Mare Island Draft Water Quality Sampling and Analysis Plan, RCRA/Facility Landfill Post-Closure Groundwater Monitoring, dated December, 2003

SUBJECT: RCRA/Facility Landfill Post-Closure Groundwater Monitoring
Mare Island Naval Shipyard, Vallejo, Solano County
Project No. 25045/200063-33/43-HWMP

Draft Water Quality Sampling and Analysis Plan, RCRA/Facility Landfill Post-Closure Groundwater Monitoring, Mare Island, Vallejo, California. Prepared by Roy F. Weston, Inc. Dated December 2003. (WQSAP)

FIGURE 4
 Figure 1 SWBZ Well Network

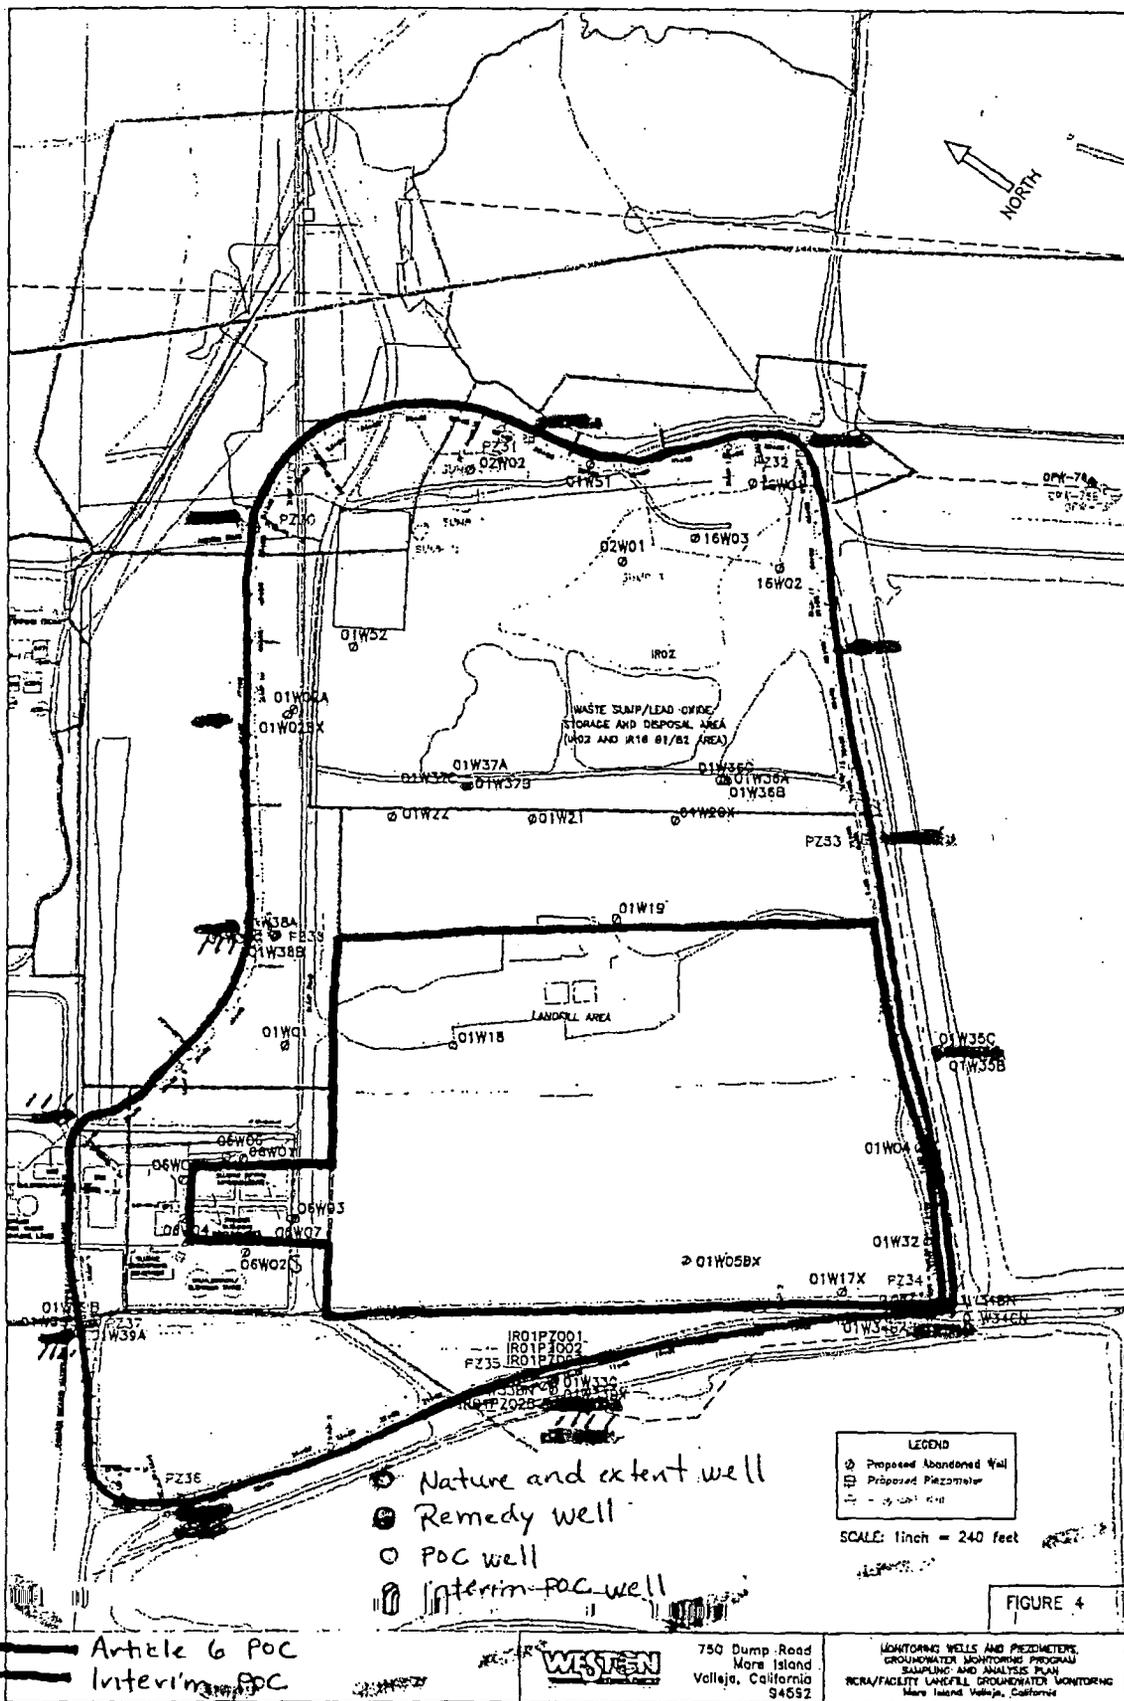
GSU recommendations for SWBZ POC and interim POC wells are depicted on Figure 1 (attached). These recommendations are consistent with the SWBZ

well network proposed in the WQSAP. As it is not clear from Figure 4 of the WQSAP, GSU assumes that replacement wells will be installed outside of the slurry wall for wells 01W38A and 01W39A.

GSU recommendations for wells useful in assessing the nature and extent of contamination are shown on Figure 1 (attached). MINS must propose additional SWBZ wells that address the data gaps identified in Sections 4.1.7, 6.4, and 7.4 of DTSC (2004).
